TECHNICAL NOTE 2

Job Name: Land East of Lunce's Hill, Haywards Heath, West Sussex

Subject: Transport Addendum Note – in response to West Sussex County Council Highways

Planning Reference: DM/25/0827

Client/Project:	Catesby Estates	
Project No.:	332611520	
BB	BB	DL 2025/03/21
Drawn:	Design:	YMM/AM/DO
Title:	LAND AT LUNCES HILL - HAYWARDS HEATH	
FEATURE OPTION	HAYWARDS HEATH SITE ACCESS	
Scale:	1:200	
Revision:	P01	
Drawing No.:	332611520-STR-HGH-XX-DR-C-0103

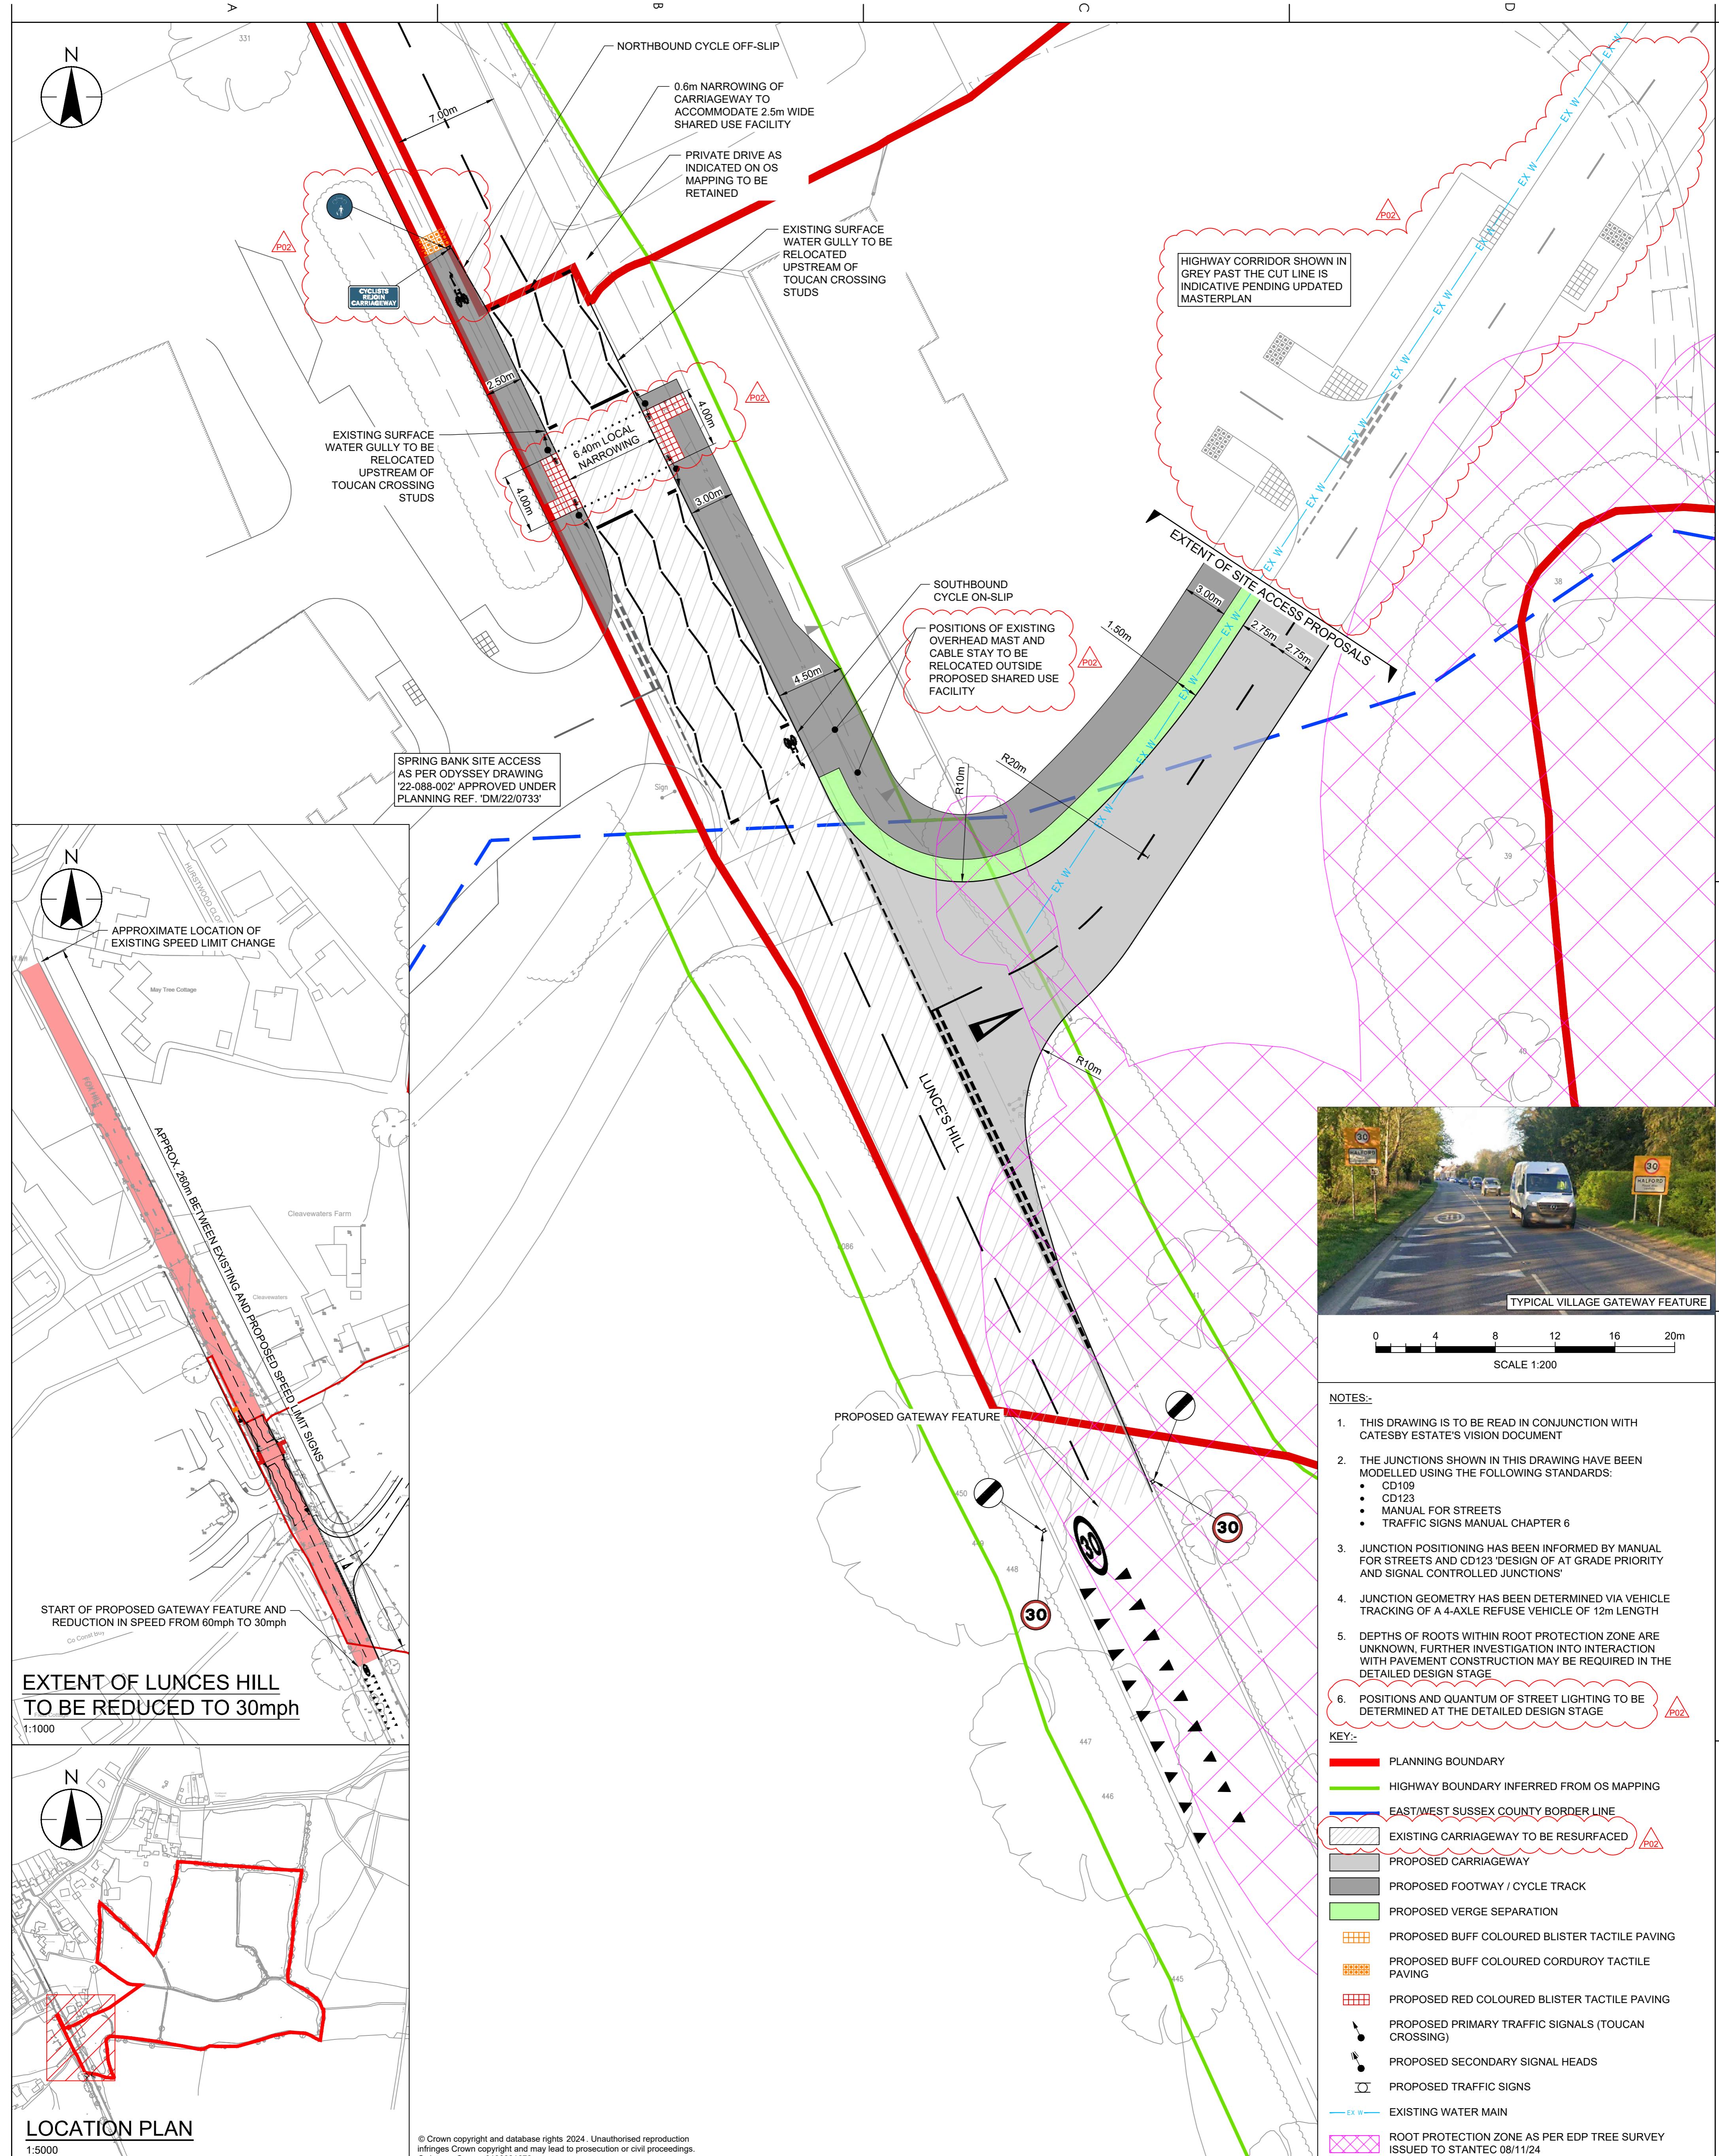
“Given the presence of the crossing at the point the speed limit changes, WSCC recommends that the extent of the new 30mph speed limit be extended southwards to take-in both the crossing and access to the development AND that the street lighting along Lunce's Hill be extended too, up to and including the new access to highlight both it and the crossing. Visibility splays, in accordance with 85th%tile speed surveys, should also be shown on any revised drawings, as well as drawings showing the visibility splays along the vertical plane given that there is a crest and overhanging vegetation south of the access point.”

"Applicant to confirm if the Puffin reference is a typo or not. However, given the design, WSCC consider that it should be a Toucan. And as such, WSCC's standard width is 4.0m and therefore the crossing will need to be widened from the 3.2m shown. Applicant to amend."

- 2.4. The two site access drawings are provided in **Appendix A**.
- 2.5. With reference to WSCC comment, and as shown on Drawing '332611520-STN-HGN-XX-DR-C-0103 P02', the proposed gateway feature and speed limit reduction would include both the proposed site access and proposed toucan crossing facility.

- 2.13. Stantec drawings '332611520-STN-HGN-XX-DR-C-0100 P08' and '332611520-STN-HGN-XX-DR-C-0103 P02' show the proposed toucan crossing designed with a width of 4.0m.
